North Hertfordshire District Council

Building Conservation comments

File Ref: 24/01582/FP & 24/01583/LBC

Subject: Alterations to covered oak frame structure providing external cover to courtyard area.

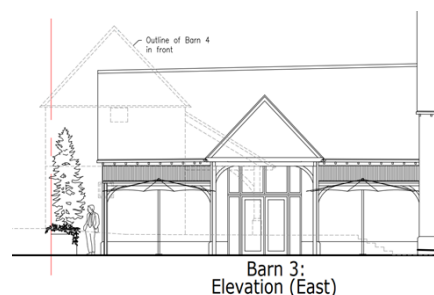
I previously inspected the way in which the structure abuts both buildings (see comments under refs: 23/02519/LBC & 23/02518/FP. I previously stated that the functional design and form, materials and scale of the existing structure are visually obtrusive, and the structure fails to respect the historic setting of Redcoats Farmhouse. I previously said that there would be a public benefit in facilitating and maintaining the effective and viable operation at Redcoats and in helping to secure a long-term viable future of these listed buildings and continued public appreciation of their agrarian historic interest. There are also economic benefits from employment opportunities in the business and local spend.

As stated in the DHS, *'the proposed alterations to the existing covered area is to remove the pitched section of roofing and the two sided thus producing a pagoda style structure giving a visual connection between the barns and the granary building. There is an infill with corrugated roofs either side of the gable structure. These will incorporate metal gutters that will be connected via new RWP to the existing soakaway drainage system. The pagoda structure will incorporate a material cover that can provide shelter in the wetter months. This will be incorporated within the structure and the cover will be designed to be retractable.'*

This is illustrated in the plan extract below. The corrugated roof lean-to's either side of the midstreys appear as outshuts and have an agrarian character whilst removing the apex of the tented structure will reveal the weatherboarded gable of the midstreys as originally intended.

1. The following items shall be removed within 6 months of the date of this decision notice:
 - i) The canvas covering to the existing structure as-built;
 - ii) The oak-framed gable structure above the pergola (which is retained under this consent); and
 - iii) The oak corner posts at the front of the structure as-built and which no longer serve a purpose in the scheme as hereby granted.

2. Details of the roof material for the lean-to's shall be submitted to and approved in writing by the Local Planning Authority prior to the commencement of that part of the development hereby consented. Thereafter the lean-to roofing shall be implemented in accordance with the approved details.

3. The new rainwater goods shall be black-painted metal or black metal-effect unless otherwise agreed and approved in writing by the Local Planning Authority.
